55 Vastern Road, Reading

# Rebuttal Proof

Design

Appeal to the Secretary of State against the decision of Reading Borough Council under section 78 of the Town and Country Planning Act 1990.

Figure 1 (Figure 23 from main proof) showing the Reading grid.

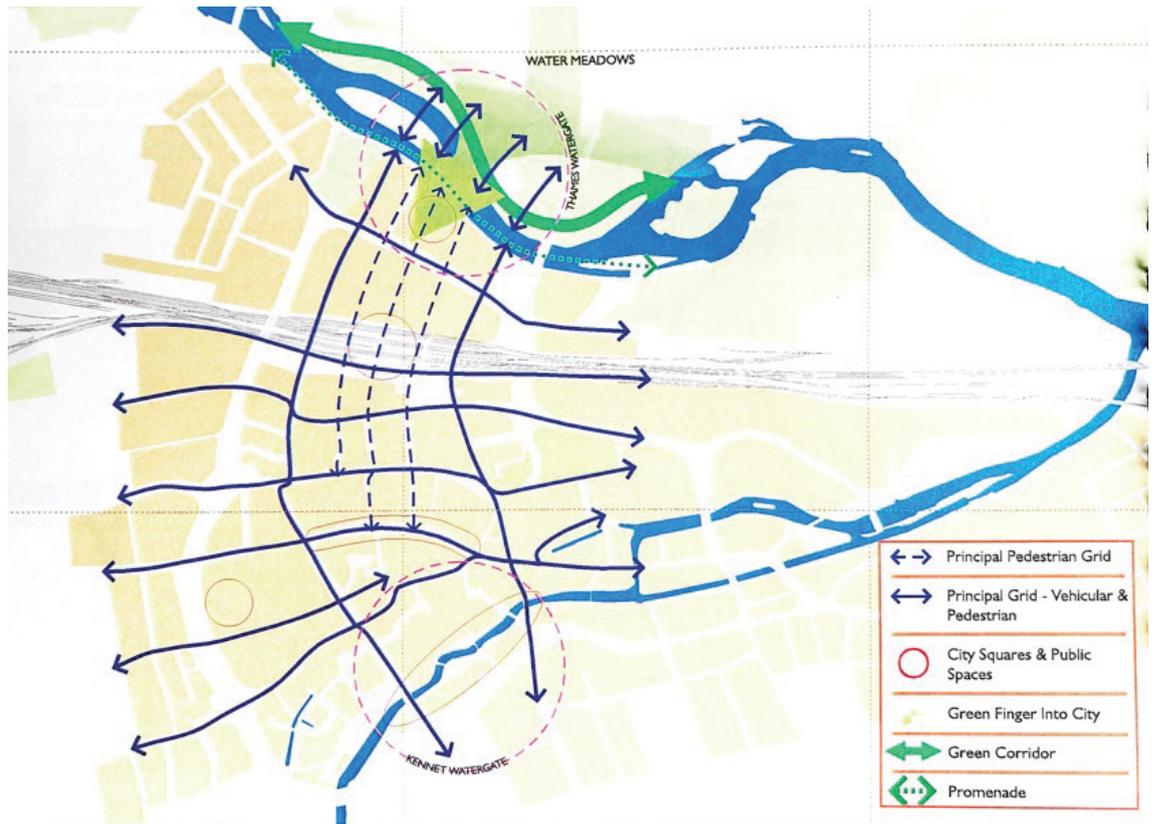
- 2.2.7 Mr Clark claims (fifth bullet) claims the north-south link reflects the historic development of key routes through Reading which, like many other successful routes through urban areas, do not rely on long, straight axial corridors but instead provide short and/or curving visual corridors, providing a sequence of focal points that invite progression along the route. I disagree with this characterisation, which contradicts the principle of extending the historic grid of the central area to the river set out in policy and guidance. Figure 15 shows what is meant by the grid.

Figure 2 Mr Clark's Figure 15 with the emerging grid overlaid.

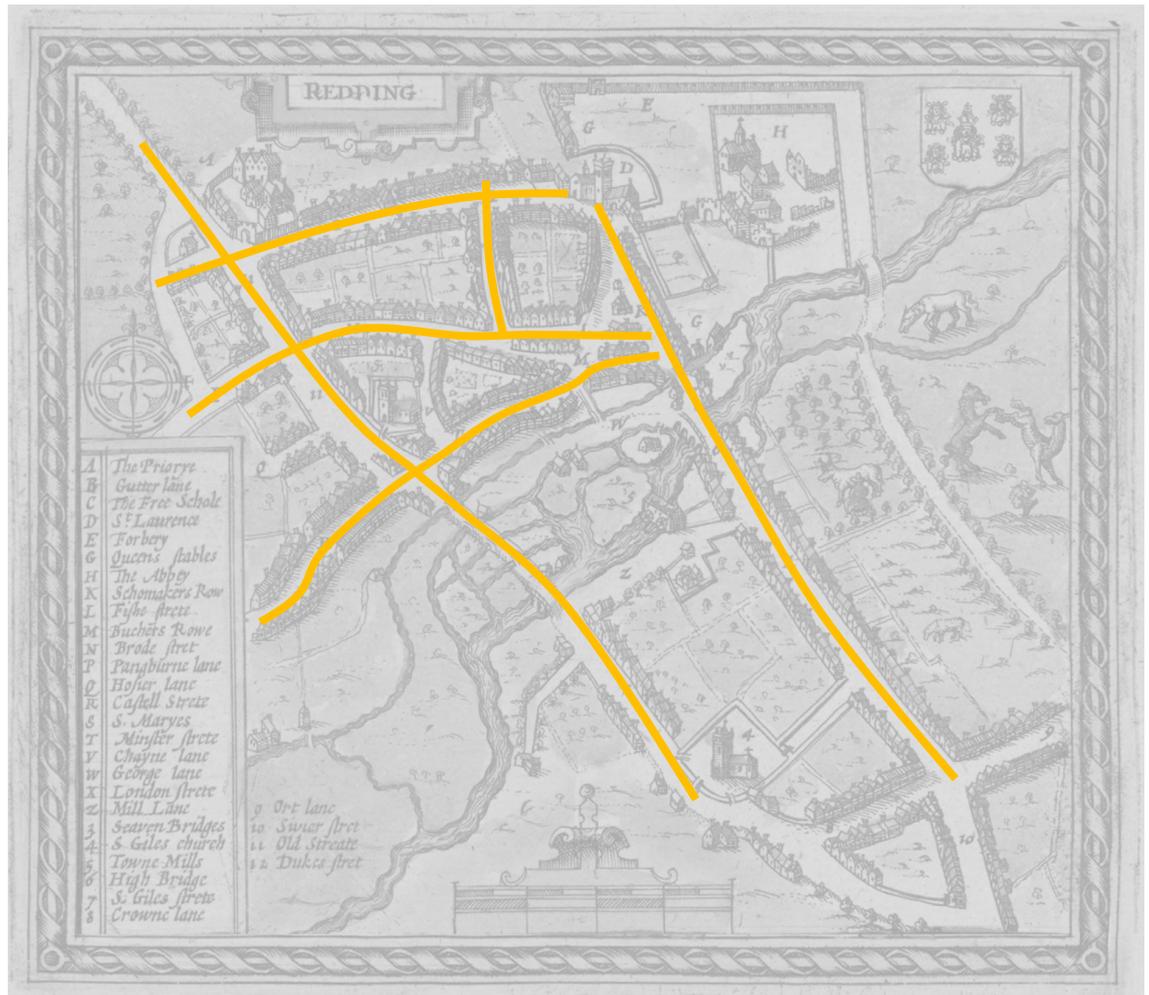
- 2.2.10 I accept the grid is distorted, but do not accept the general urban morphology/space syntax is one of '*short and/or curving visual corridors, providing a sequence of focal points that invite progression along the route*'. The routes I have shown in orange are long and comparatively straight.

2.2.11 I have explained how the historic grid is distorted to some extent, from which Mr Clark draws the mistaken conclusion that the town centre is characterised by 'short and/or curving visual corridors. In any case, the Appeal Scheme does not propose curving visual corridors.

Figure 4 Extract from my PoE 34 showing one possible arrangement of a direct route and direct line of site (blue arrow).

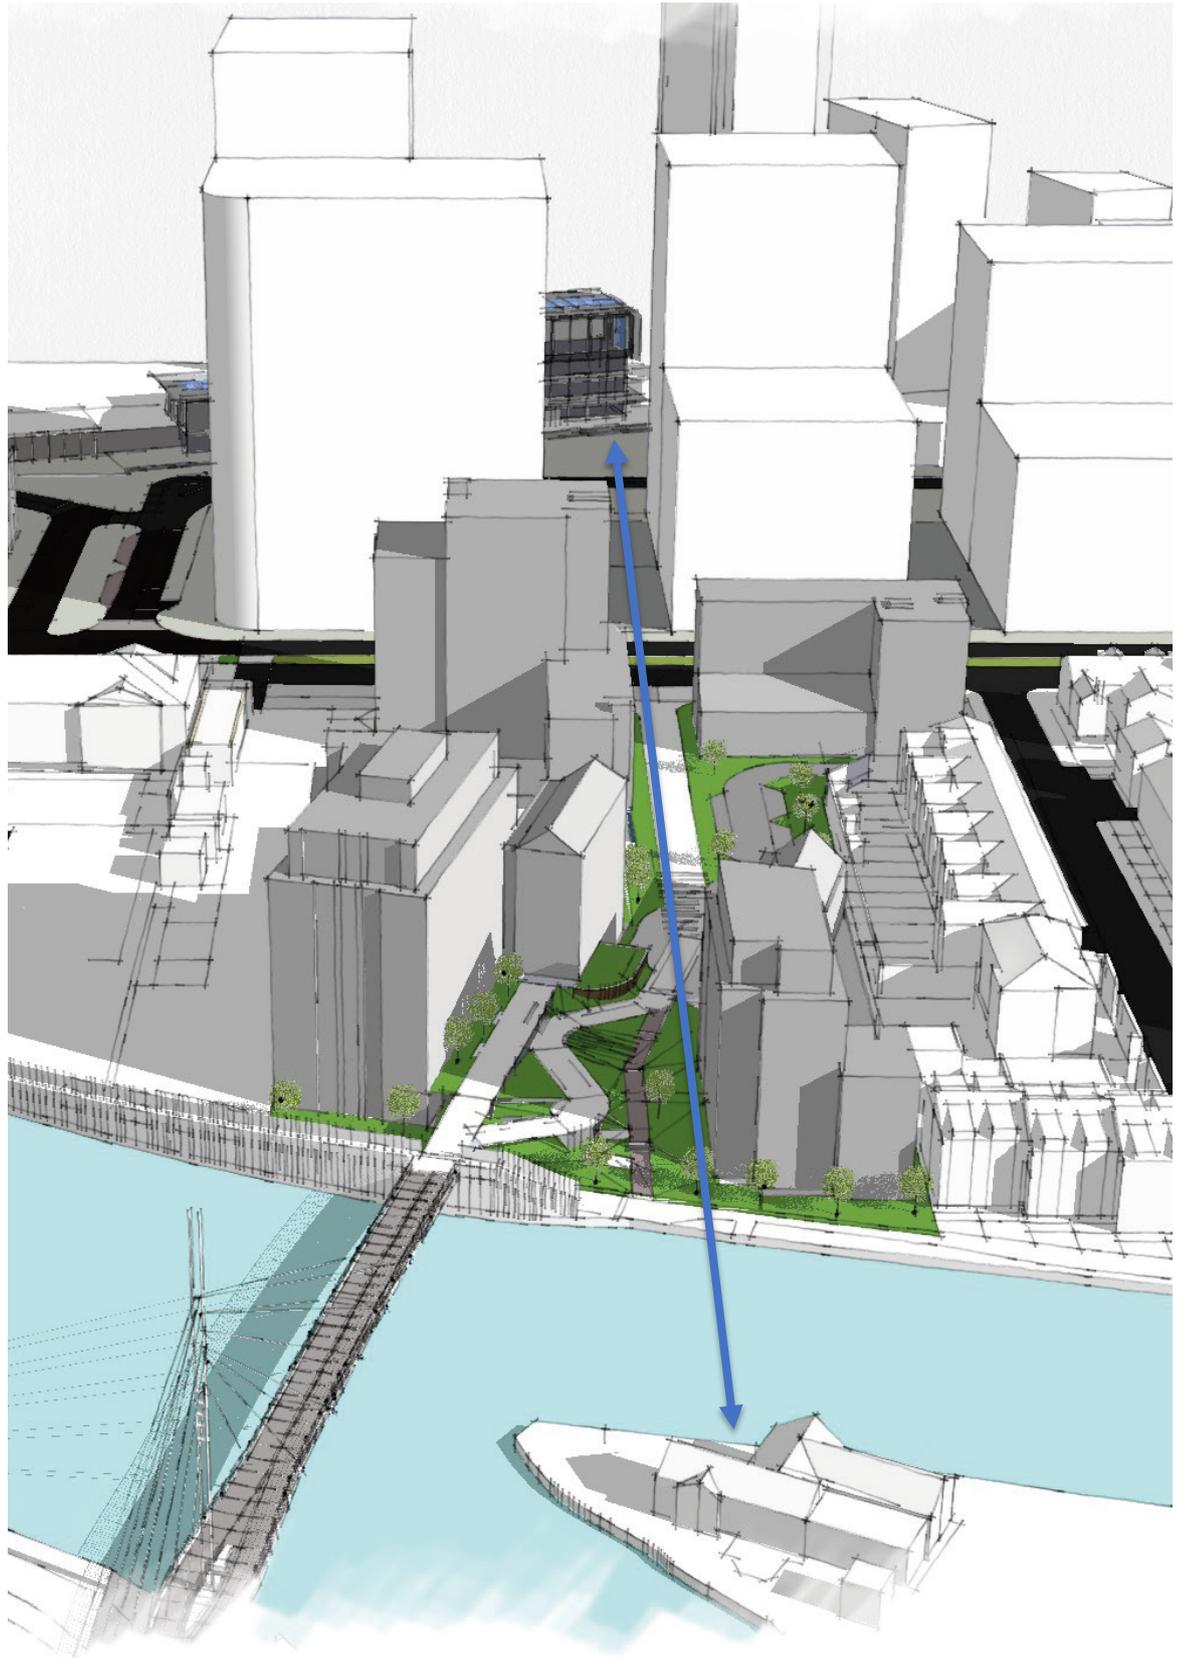
- 2.3.25 Mr Clark claims the sequential enclosure of sightlines is an entirely acceptable and well-established approach to providing an attractive and legible pedestrian route. This may be acceptable on another site, in a different context, and under a different set of local policies and guidelines, but it is entirely unacceptable here.
- 2.3.26 Mr Clark claims the sequential enclosure of sightlines is justified because it is impossible to create a direct route and direct line of sight on the Appeal Site. The LPA case is that a direct route is feasible, and I have demonstrated that in my evidence that a direct route and a direct line of site are possible (see Figure 4).

Figure 5 Cross-section from the River to the Station showing the long setback distances between buildings shown in MR Clark's Figure P2

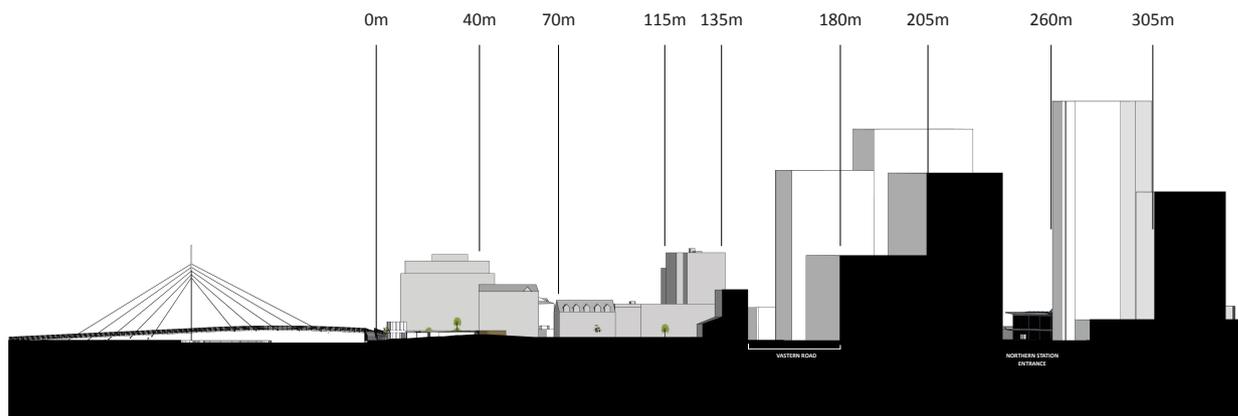
2.4.29 Mr Clark suggests his cumulative montage P2 shows that the skyline would be dominated by development within the Station Area Cluster cumulative schemes and my comment (SoC 3.10.1) that the broader skyline backdrop of the bridge is 'impressive' fails to recognise this. My statement relates to the TVIA baseline - the site and setting today - which Clark has been unable to describe in a sufficiently accurate and balanced way (riverfront heights, openness, utilitarian void etc.).

2.4.30 Mr Clark is misreading what is shown at P2 and fails to address the specific focus of RFR2. This is partly the result of limitations in what is shown in drawing P2. The LP envisages a tall building cluster around the station with lower-rise buildings towards the river, the Meadow, and lower-rise dwellings. The RSAF envisages a gradual increase in height from six storeys at the riverfront rising to the tall building cluster around the station. The RSAF envisages some taller landmark buildings rising higher than surrounding 'benchmark' heights within this gradation, although these are the exception. Viewed from the riverside and Meadow, this would create a 'layered effect' of lower foreground buildings rising gradually to taller buildings to the rear. The Appeal Scheme exceeds<sup>9</sup> (double<sup>10</sup>) the RSAF height guidance, introduces landmark buildings where none are proposed in guidance, and includes buildings rising to just below the CR10 tall building thresholds. Whilst I accept there is some scope to vary the relative heights and massing (and the RSAF anticipates this, e.g., RSAF Figure 6.5), RfR 2 focuses explicitly upon the failure to lower heights at the riverfront - the foreground.
